IFB #25-100
1900 2nd Ave North, Community Sustainability
Expansion Project

Change Order Requests

1900 2nd Ave North, Community Sustainability Expansion Project

CHANGE ORDER REQUESTS

**OVERHANG
FRAMING DETAIL**

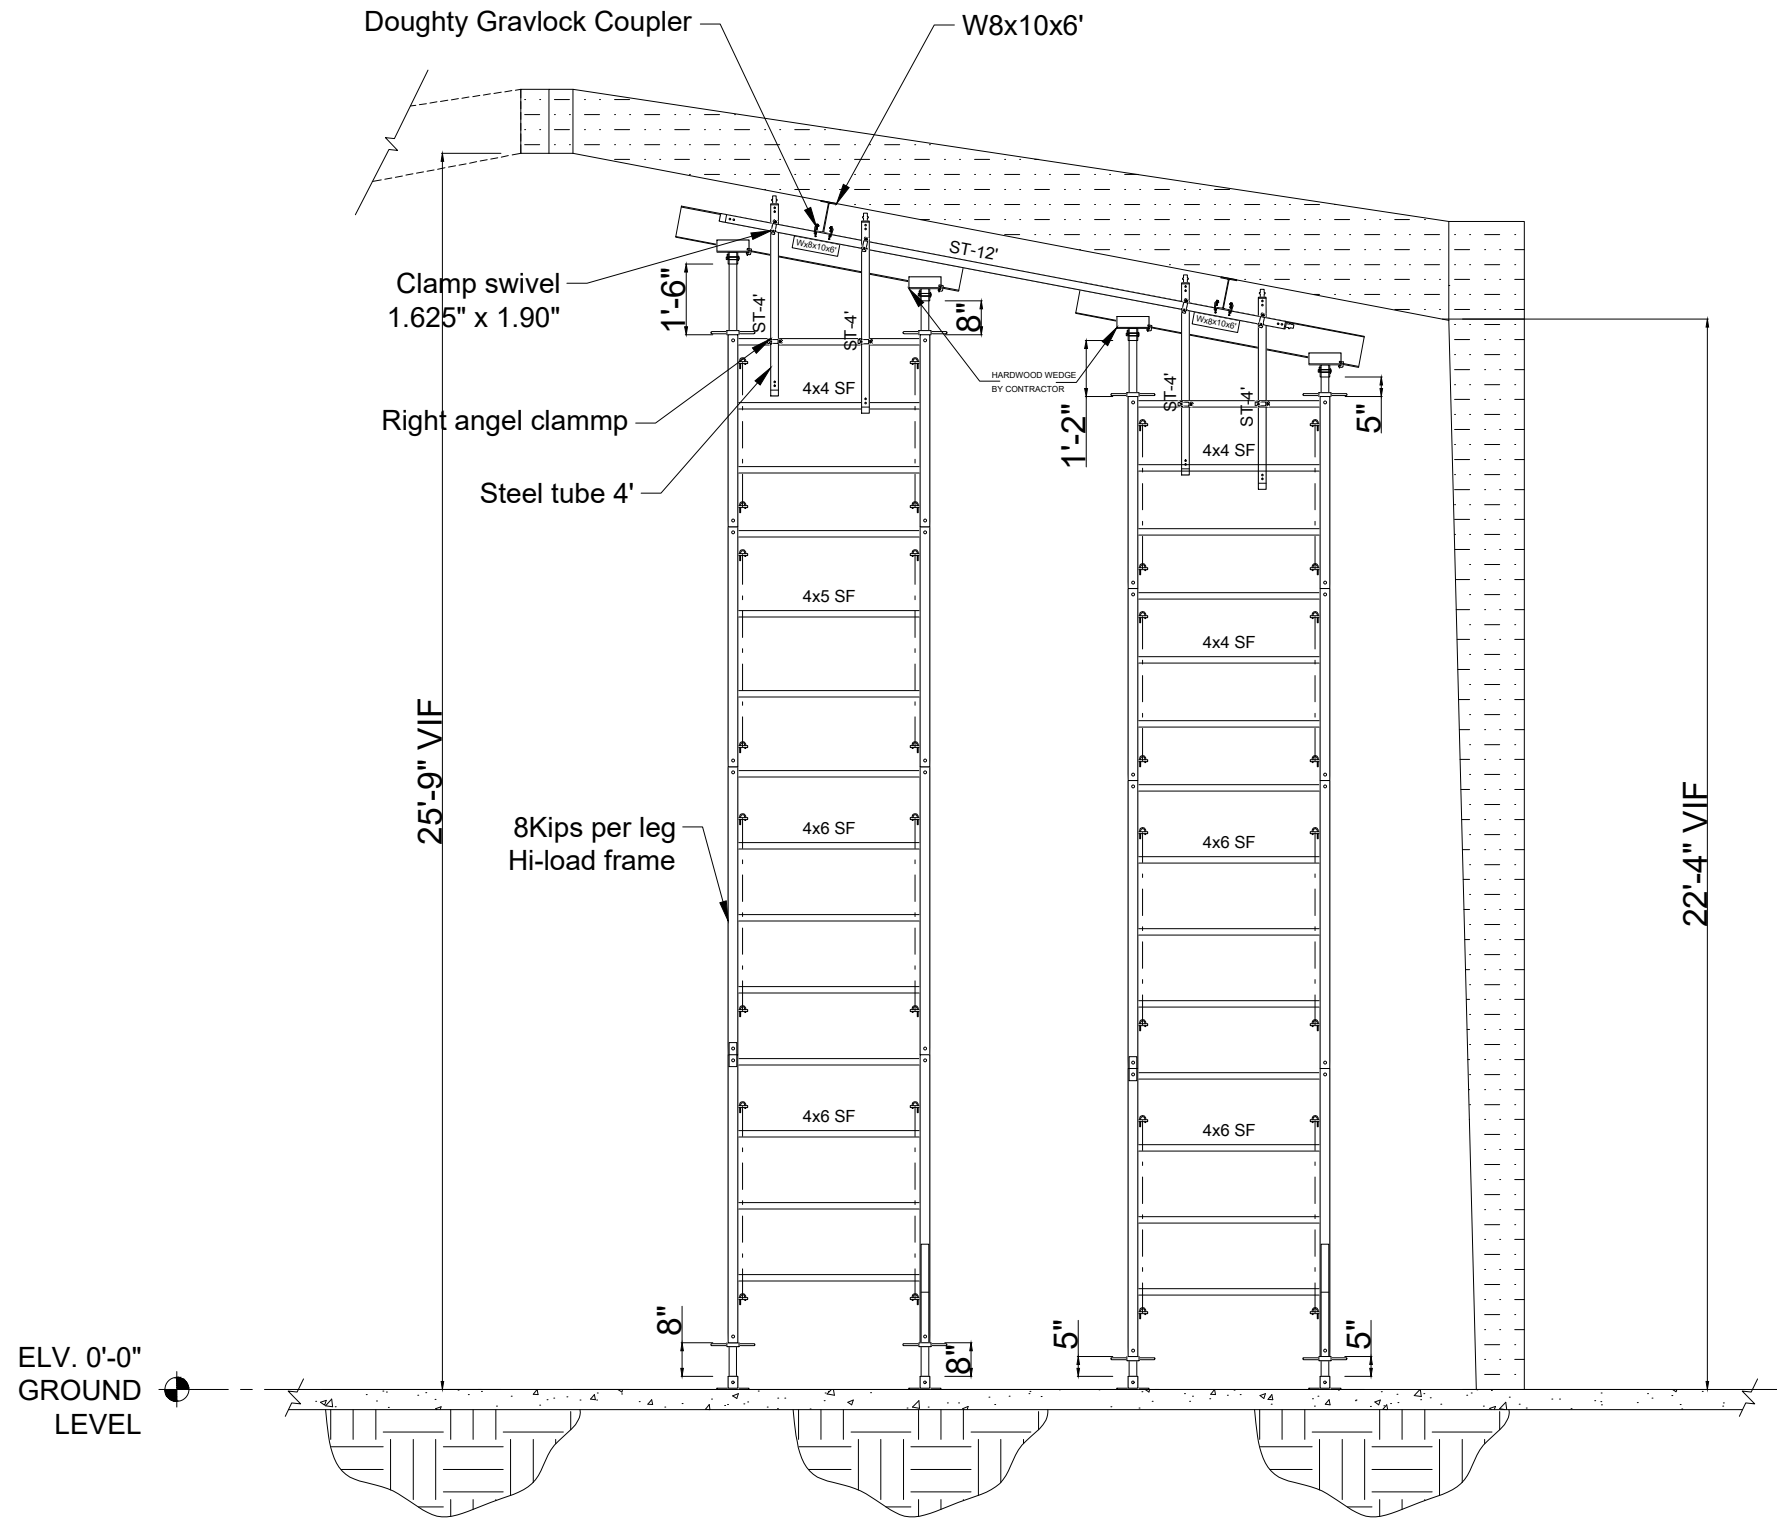
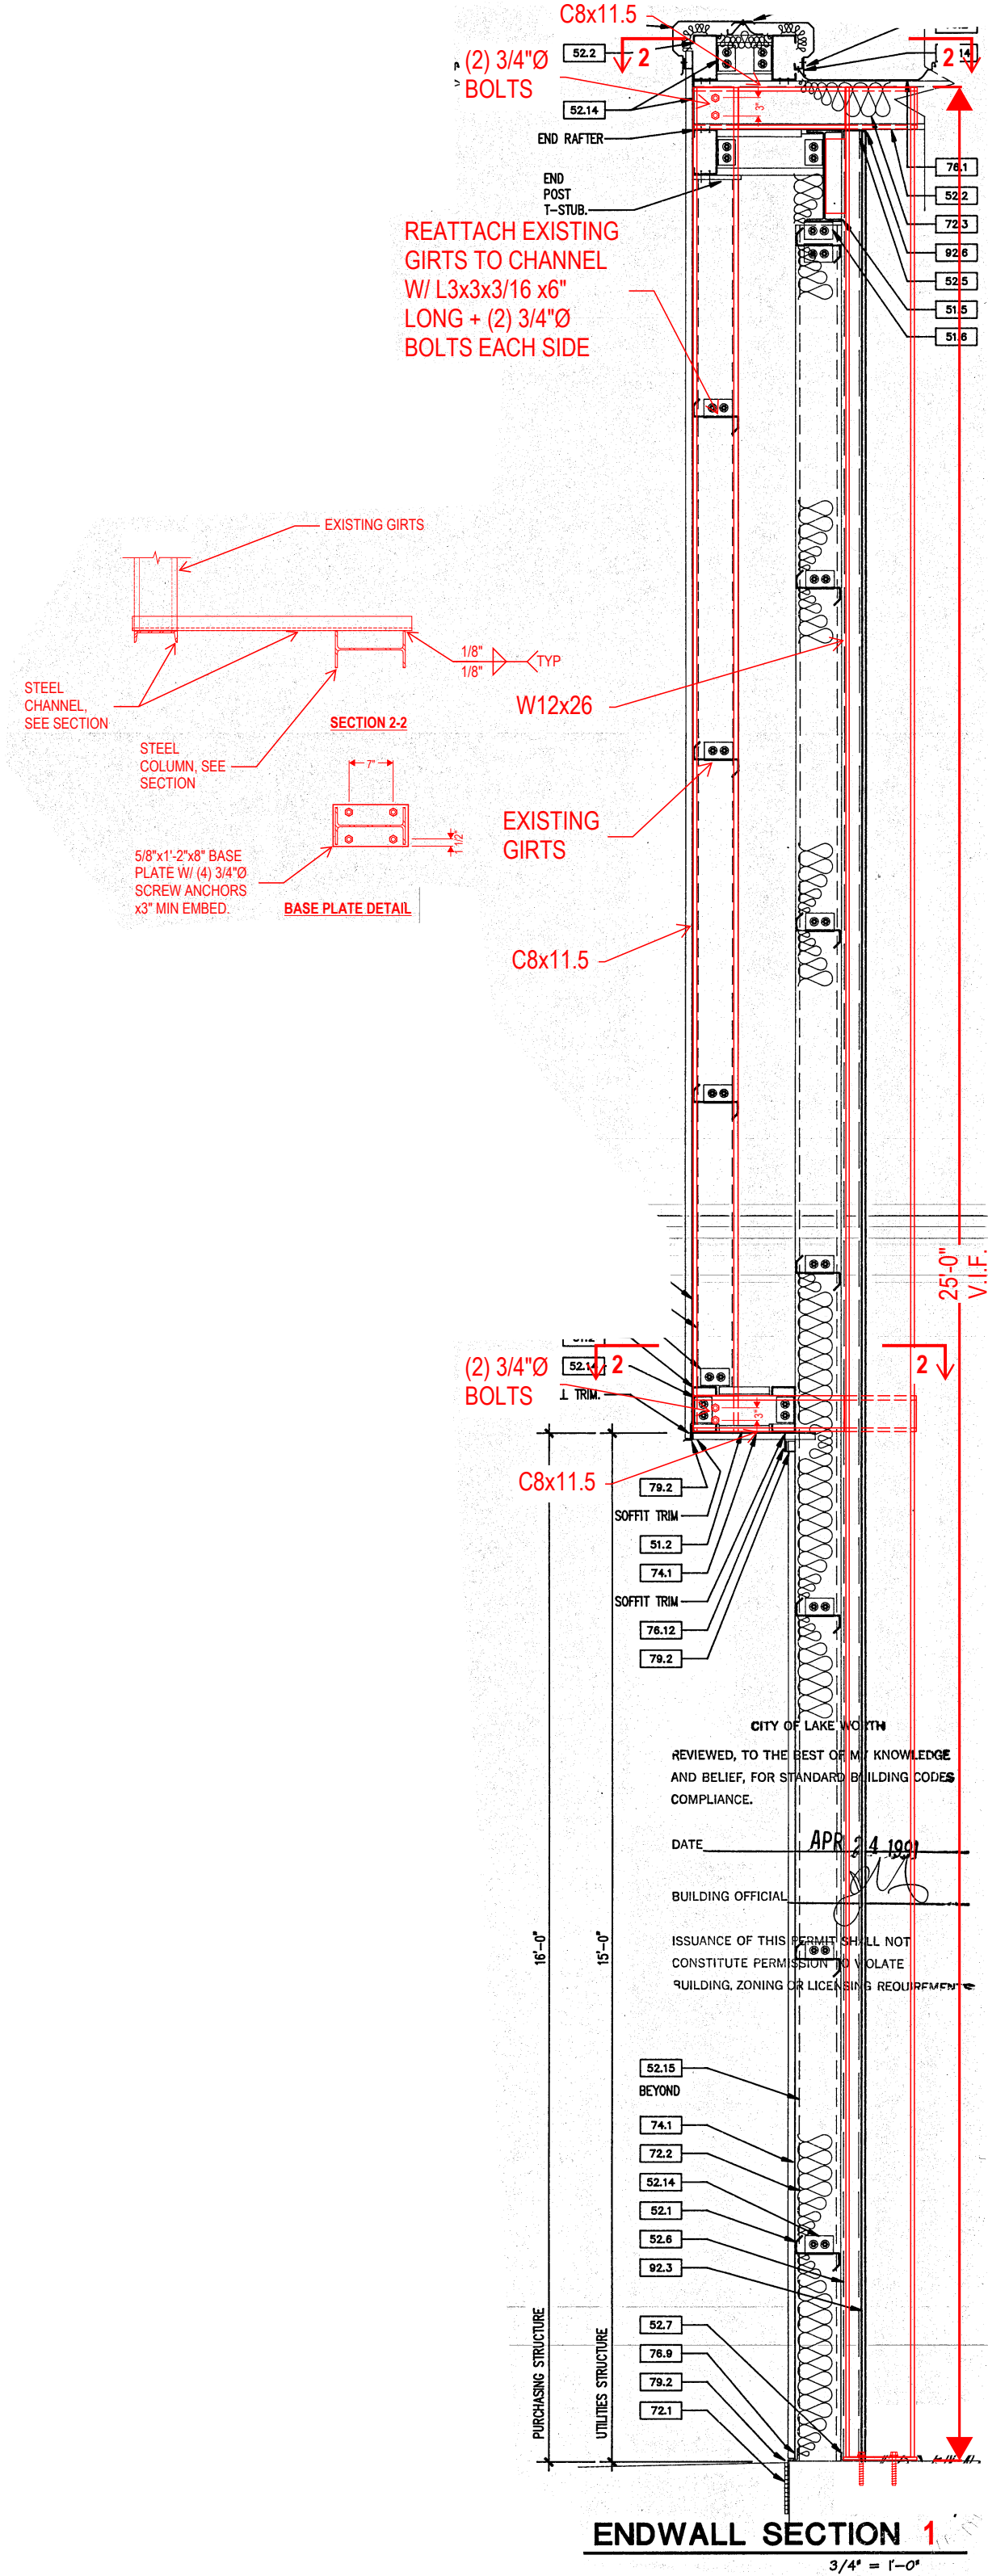
Provide and install supplemental structural framing required to support the existing overhang in accordance with the overhang framing detail shown on Sketch SSK-001 (attached).

The framing detail was developed in response to RFI No. 011 and was not included in the original contract documents issued for bidding. This work is necessary to properly transfer structural loads and maintain adequate bracing of the existing metal building system in conjunction with the new building expansion.
